# **E C O L O G I C A L   R E V I E W**

**Raccoon Island Shoreline Protection/Marsh Creation, Phase A**  
CWPPRA Priority Project List 11  
State No. TE-48

September 16, 2004

This document reflects the project design as of the 95% Design Review meeting, incorporates all comments and recommendations received following the meeting, and is current as of September 16, 2004.

Figure 3: TE-48, Phase A, project features.

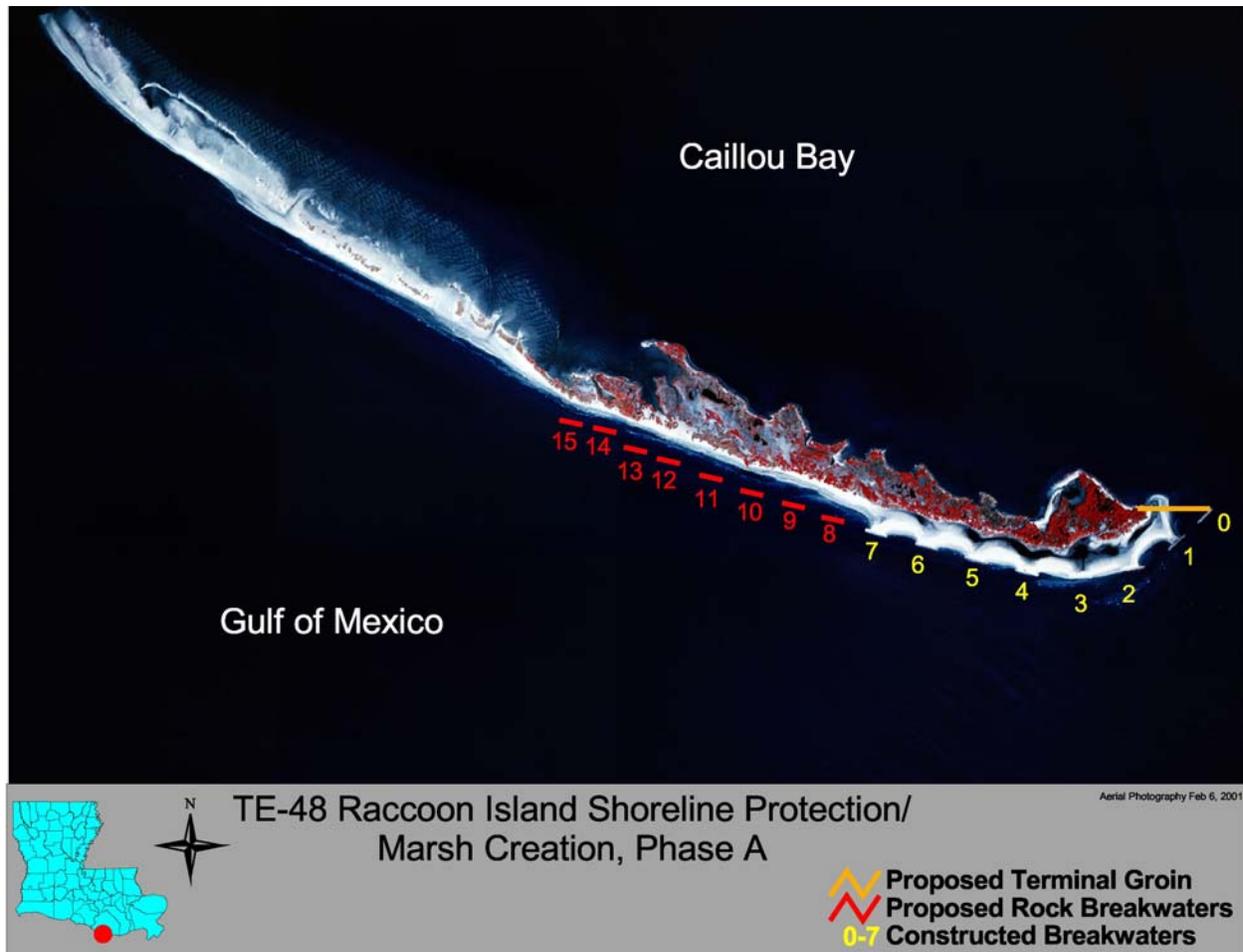
The project is anticipated to reduce the rate of shoreline erosion by approximately 60% through the construction of eight segmented breakwaters as a westward continuation of the Raccoon Island Breakwaters Demonstration (TE-29) project, and construction of a terminal groin at the eastern end of the breakwater field (Figure 3).

Eight additional segmented breakwaters will be constructed as a westward continuation of the TE-29 demonstration project. The eight, 300-foot long breakwaters will be constructed approximately 250 feet from shore, in 3 to 8 feet of water. Each breakwater will be constructed at a crest elevation of +4.5 feet NAVD-88, with a 10-foot crown and 1(V):3(H) side slopes. The gap between each breakwater will range from 160-300 feet based on results and recommendations from the sediment budget (Coastal Planning and Engineering, Inc. 2004) (Table 1).

An 952-foot terminal groin will be constructed at the eastern end of the breakwater field from the island to the end of breakwater 0, to stabilize the eastern end of the island and reduce tidal currents between breakwaters 0, 1, and 2, and the shoreline. The eastern terminal groin will be constructed at a crest elevation of +4.5 feet NAVD-88, with a 10-foot crown and 1(V):3(H) side slopes.

The development of the sediment budget enabled the design team to refine the design of the project, through the modification of the length of the gaps between breakwaters, and incorporating the addition of a terminal groin at the eastern end of the breakwater field. The design had originally incorporated a 600-foot terminal groin at the western end of the breakwater field from the island to the end of breakwater 15, to capture most of the sediment that would otherwise have passed through the breakwater field and been lost to the emergent portion of the island. The western groin would have greatly reduced the loss of sediment through longshore transport, which is predominantly east to west, and would have reduced shoreline erosion rates behind the proposed breakwater field on Raccoon Island by approximately 75% (from 52 feet/year to 12 feet/year, based on model calculations performed by Coastal Planning & Engineering, Inc. [2004]). Construction of the western groin would likely have resulted in an erosional shadow in the area to the west of the structure, caused by a sediment deficit. Because of the location of the structure at the western end of the island the emergent, vegetated portion of the project area would not have been affected; however, the sand spit located down drift from the structure would likely have been starved of sediment. After some concerns were expressed over the western terminal groin's potential impact on the sand spit, it was decided to remove the structure from the project design. This will likely result in a reduction of benefits to the project area, as the western terminal groin was expected to reduce shoreline erosion by an additional 15% (75% reduction with the groin and 60% reduction without the groin). The removal of the western terminal groin will result in an estimated increase in shoreline erosion of 9 feet/year (from 12 feet/year to 21 feet/year). This is equivalent to a loss of emergent vegetated island habitat of approximately 17 acres over the 20-year project life.

The 952-foot terminal groin that is designed at the eastern end of the breakwater field from the island to the end of breakwater 0, should stabilize the eastern end of the island and reduce tidal currents between breakwaters 0, 1, and 2, and the shoreline. This should result in the accretion of an additional 6 acres of beach, if the sediment from the shoal continues on being available (Coastal Planning and Engineering, Inc. 2004).

After review of the design of the project, the results of the sediment budget, and review of the monitoring information from previous breakwater projects in Louisiana, it is the opinion of the LDNR project team that the project will likely achieve the goal of reducing the shoreline erosion rate in the gulfside project area by approximately 60% (from 52 feet/year to 21 feet/year).

Based on information gathered from similar restoration projects, engineering designs and related literature, the proposed strategies in the Raccoon Island Shoreline Protection/Marsh Creation, Phase A project will likely achieve the desired goals. At this time, the Louisiana Department of Natural Resources, Coastal Restoration Division recommends that the Raccoon Island Shoreline Protection/Marsh Creation, Phase A project be considered for CWPPRA Phase 2 authorization.
